## MEDIC UPDATE

### TECHNICAL SERVICE BULLETIN

SUBJECT:			No: <b>TSB-07-13-003REV</b>
<b>WHISTLE NOISE FROM ENGINE COMPARTMENT</b>			DATE: <b>April, 2007</b>
			MODEL: <b>2007 Raider 3.7L</b>
CIRCULATE TO:	<input type="checkbox"/> GENERAL MANAGER	<input checked="" type="checkbox"/> PARTS MANAGER	<input checked="" type="checkbox"/> TECHNICIAN
<input checked="" type="checkbox"/> SERVICE ADVISOR	<input checked="" type="checkbox"/> SERVICE MANAGER	<input checked="" type="checkbox"/> WARRANTY PROCESSOR	<input type="checkbox"/> SALES MANAGER

*This TSB supersedes TSB-07-13-003, issued January, 2007, to revise the **PURPOSE** section, update the **AFFECTED VEHICLES** section and the labor operation number. Revised information is indicated by ►.*

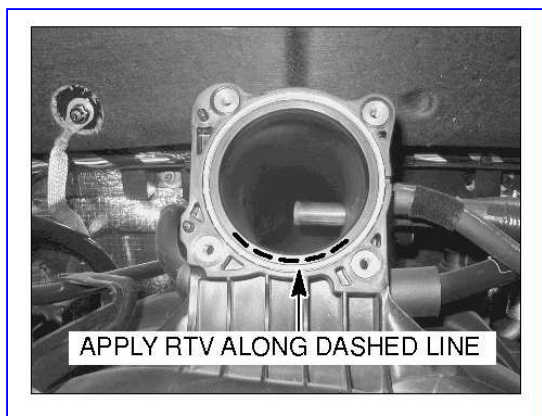
7. Apply a **small diameter bead (about 1 mm)** of RTV to the intake manifold-to-throttle body joint, **inboard of the o-ring**. The RTV is to be applied to the lower section of the joint between the lower two throttle body bolt attachment holes as shown.

8. Reinstall the throttle body. Tighten the four attachment bolts to 60 in lbs (7 Nm).
9. Wipe off all excessive RTV from the inside of the joint.
10. Reinstall the air intake tube at the throttle body.
